re: Climate Resiliency Review, Mugar Lands

SUBJECT: Resiliency review consultation services related to the East Arlington Mugar site

Weston & Sampson Engineers, Inc. (Weston & Sampson) is pleased to present this memorandum to the Arlington Land Trust to summarize climate resiliency considerations of the Thorndike Place proposed design at the East Arlington Mugar site (the "Site") being developed by OakTree Development and designed by BSC Group.

Figure 9. FEMA FIRMette for Site

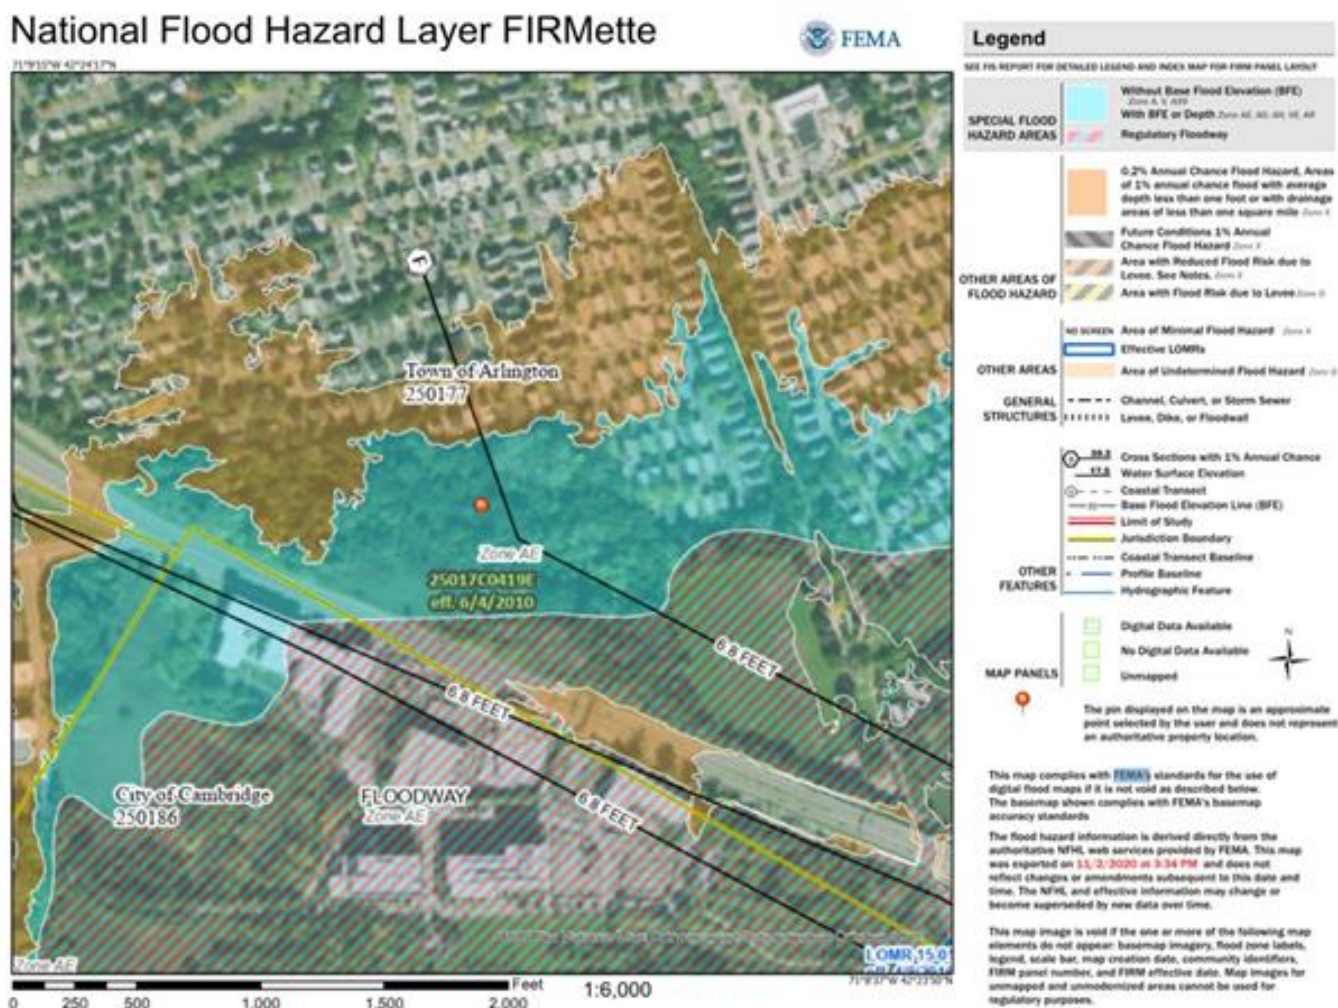
Alewife Brook (Little River)² created by FEMA, the 500-year elevation for the Site is 10.75 feet NAVD88. Furthermore, all of FEMA's elevations for the Site are based on data collected up to June 4, 2010, and do not consider SLR or SS effects due to climate change. The first floor living space for the Thorndike Place development is designed at an elevation of approximately 13 feet-NAVD88, making it suitable for projected SLR and SS effects, but the underground parking area is at a severe risk of flooding.

1. Coordinate to discuss flood elevation findings from Climate Change Vulnerability Assessments conducted by surrounding municipalities and utilize the findings to come up with a DFE that would provide flood protection for the 2070s planning horizon.

Figure 10. Map from the BH-FRM showing the 2070 1% Annual Chance Flood

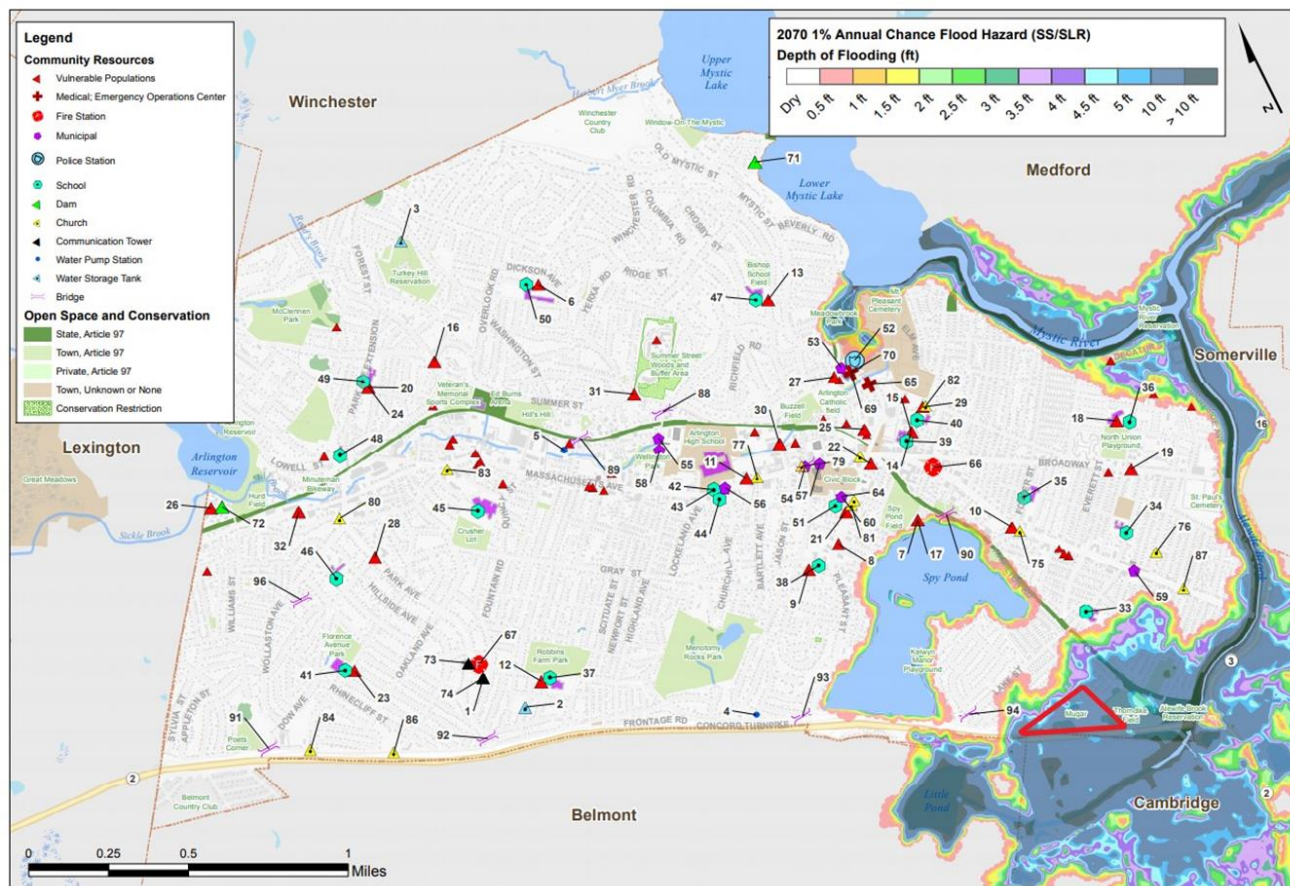
proposed development site, and the site is likely to experience a greater than 20% annual probability of flooding by 2070.³ The Department of Conservation and Recreation (DCR) is actively undertaking a Feasibility Analysis on raising and extending the AED and pursuing this effort in coordination with regional resiliency efforts. The timeline for these improvements is uncertain, which is why the Thorndike Place Development should consider these future flooding impacts. Figure 10 shows a map of the 1% annual chance flood depth projected throughout Arlington for 2070 by the BH-FRM, which was the model used in the Cambridge Climate Change Vulnerability Assessment. This map indicates a projected flood depth of at least 10 feet throughout the Mugar site.

Figure 11. Comparison of Total Storm Depths

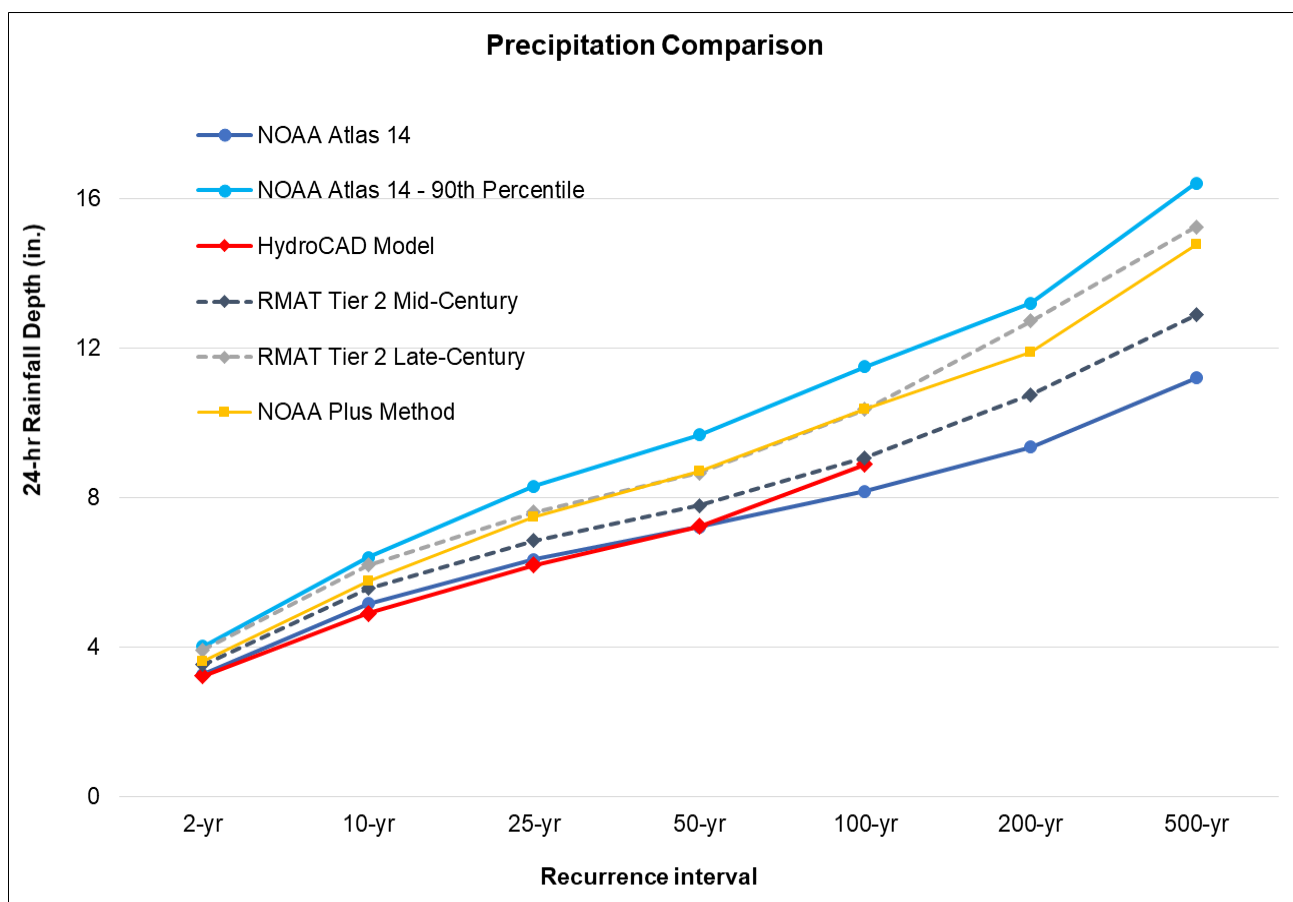
Climate resilient design for the average level of effort (“Tier 2”), as proposed by the RMAT Standards, include percent increases for NOAA Atlas 14 estimates. These percent increases for the mid-century (2030/2050) and late-century (2070/2090) show greater design storm depths than used for the proposed project. A comparative representation of the precipitation depths discussed in this memorandum is shown in Figure 11, with the corresponding values indicated in Table 1, below. It is recommended that these updated precipitation depths be evaluated within the HydroCAD model to appropriately design a stormwater management system at the Site that will be effective in the 2070s planning horizon.

2. Utilize updated 24-hr design storm depths in the HydroCAD model to appropriately design a stormwater management system that will be effective in the 2070s planning horizon. The RMAAT Tier 2 Methodology provides percent increases to the NOAA Atlas 14 design depths used in the current design of the Thorndike development. The efficacy of the proposed stormwater management at the Site should be assessed using the recommended RMAAT Tier 2 Late Century percent increases.

Figure 12. Arlington Land Surface Temperature Map, 2018

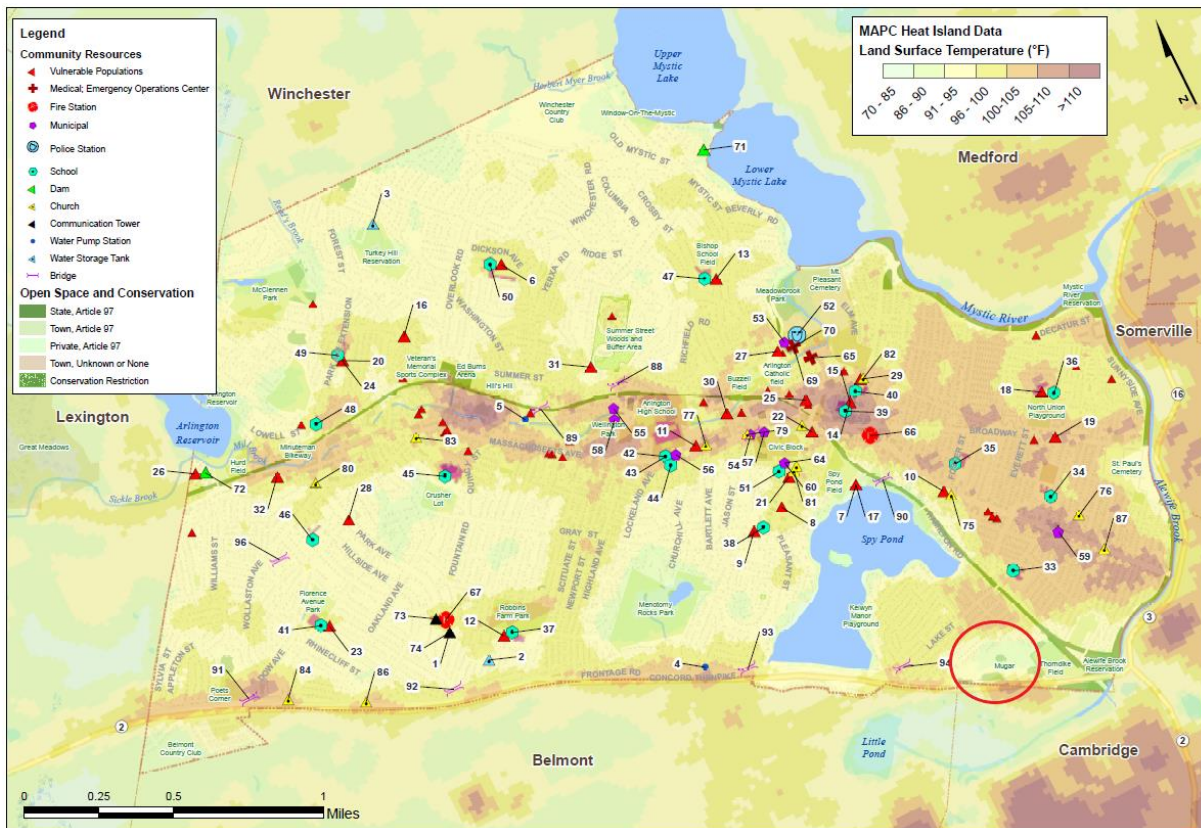
Taken from the Town of Arlington Community Resilience Building 2018 Report, Figure 12 depicts the current heat island analysis for the Arlington area based on land surface temperature¹⁰. This figure demonstrates that the Site is one of limited areas within the Town that has lower land surface temperatures. The Cambridge CCVA further shows that ambient air temperatures are projected to increase through 2070, becoming dangerous to human health, worsening the situation for already vulnerable populations expected to be living on the Site¹¹.

5. Provide information on how development of the Site will change land surface temperatures to prevent exacerbating the already increasing urban heat island effect.
